REMARKS

Amendment to the Specification

Amendments to the Drawings

Fig. 1

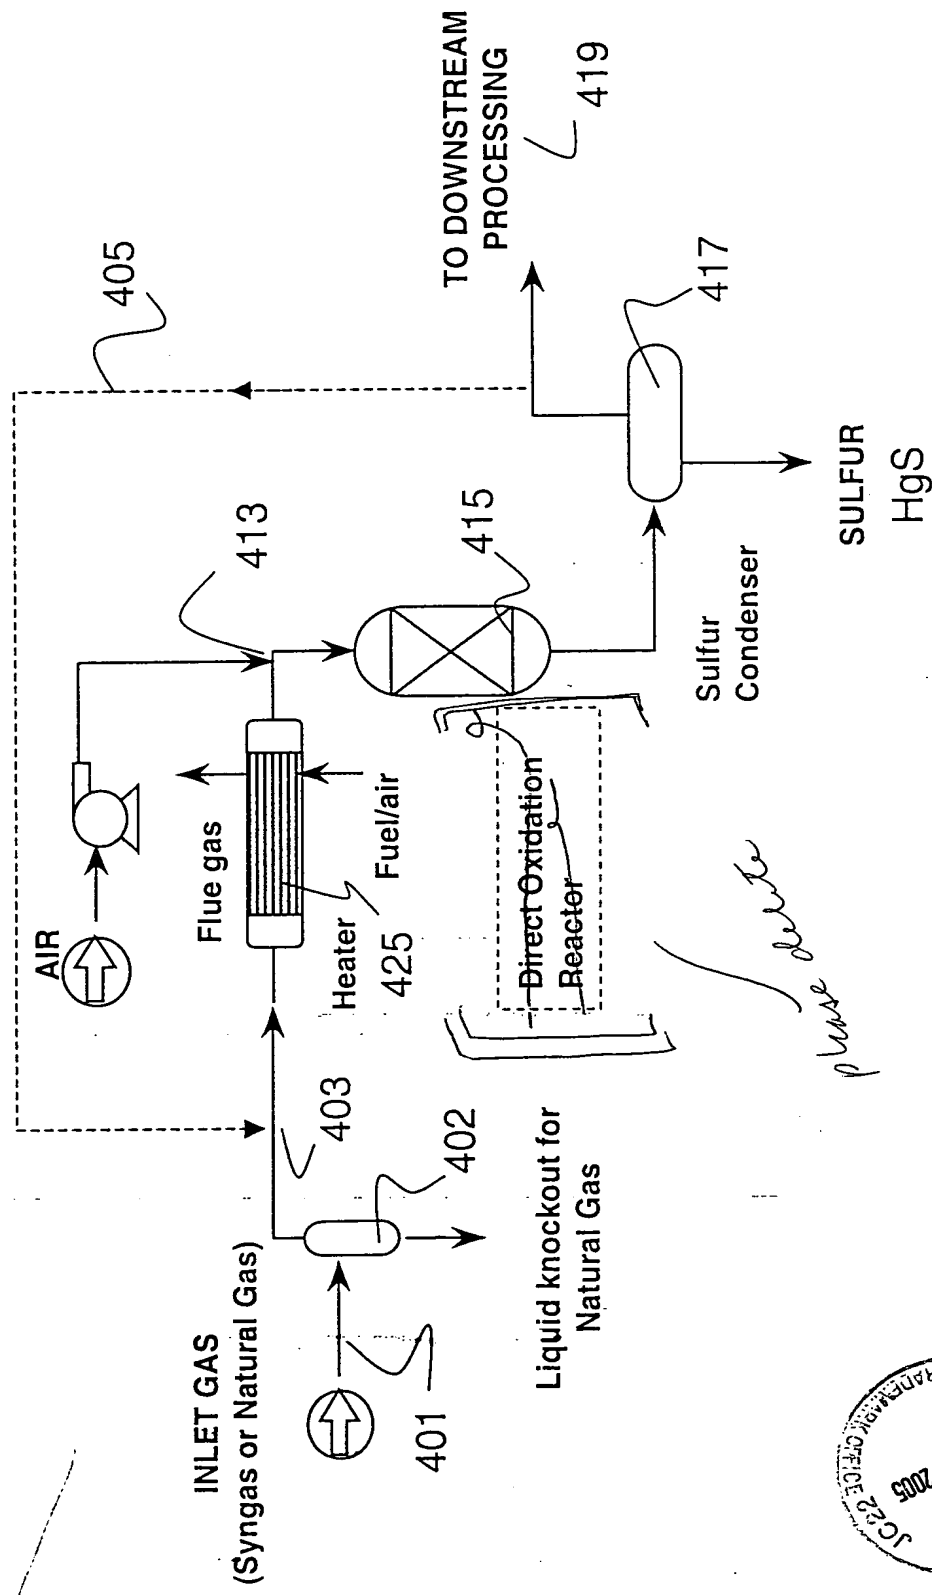
The Drawings were objected for several reasons. The Office Action states that the reference character "415" has been used in Figures 1 and 2 to refer to both the "catalytic reactor" and the "Direct Oxidation Reactor." Figures 1 and 2 have been amended to delete text and a text box the include the name "Direct Oxidation Reactor." Element 415 is the catalytic reactor. The Direct Oxidation Reactor on the Figures was intended to refer to several elements in addition to element 415. To avoid confusion the text has been removed from Figures 1 and 2. In Figure 2, the elements within the span of the bracket which is labeled reference number 501 are the components of the "Direct Oxidation Reactor." It is believed that the amendments to the drawings obviate this objection.

Figure 1 is amended to delete the box with text "Direct Oxidation Reactor." This deletion is made to improve the clarity of the drawing. The "catalytic reactor" labeled 415 is not the Direct Oxidation Reactor it is one element of the Direct Oxidation Reactor.

Fig. 3

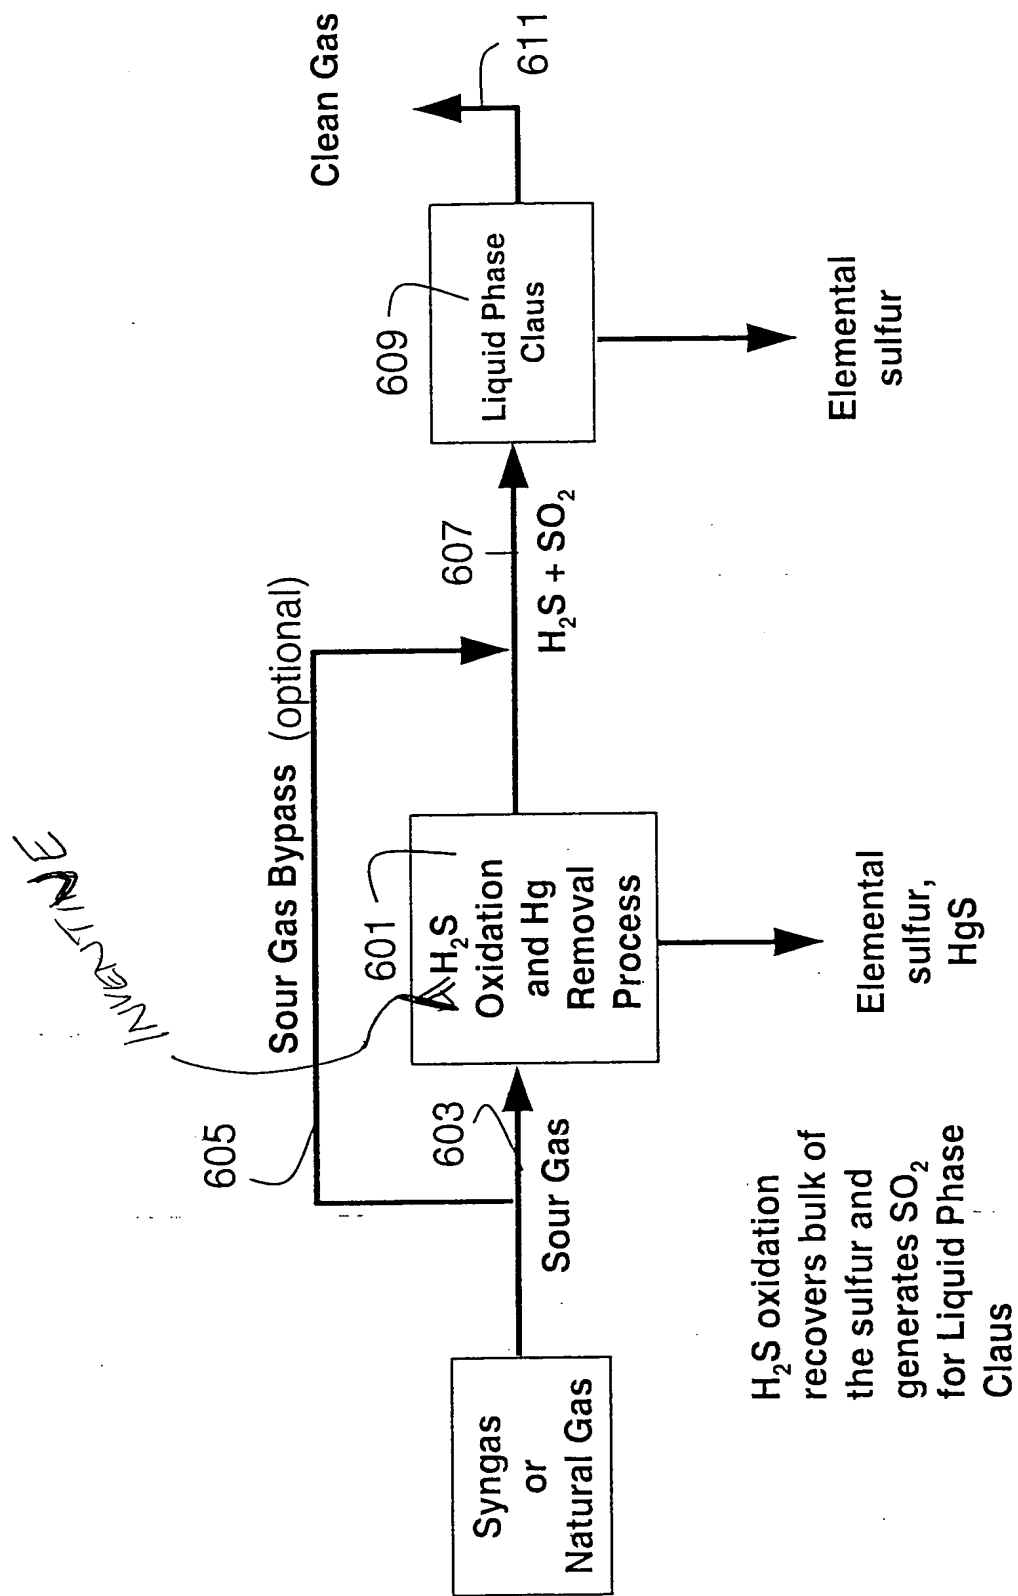
On page 6 of the Office Action, the Examiner suggests insertion of the word "Inventive" into the text box labeled 601. This amendment has been made to Figure 3.

Figure 3 is amended as suggested by the Examiner to insert the word "Inventive" in the text box labeled 601.
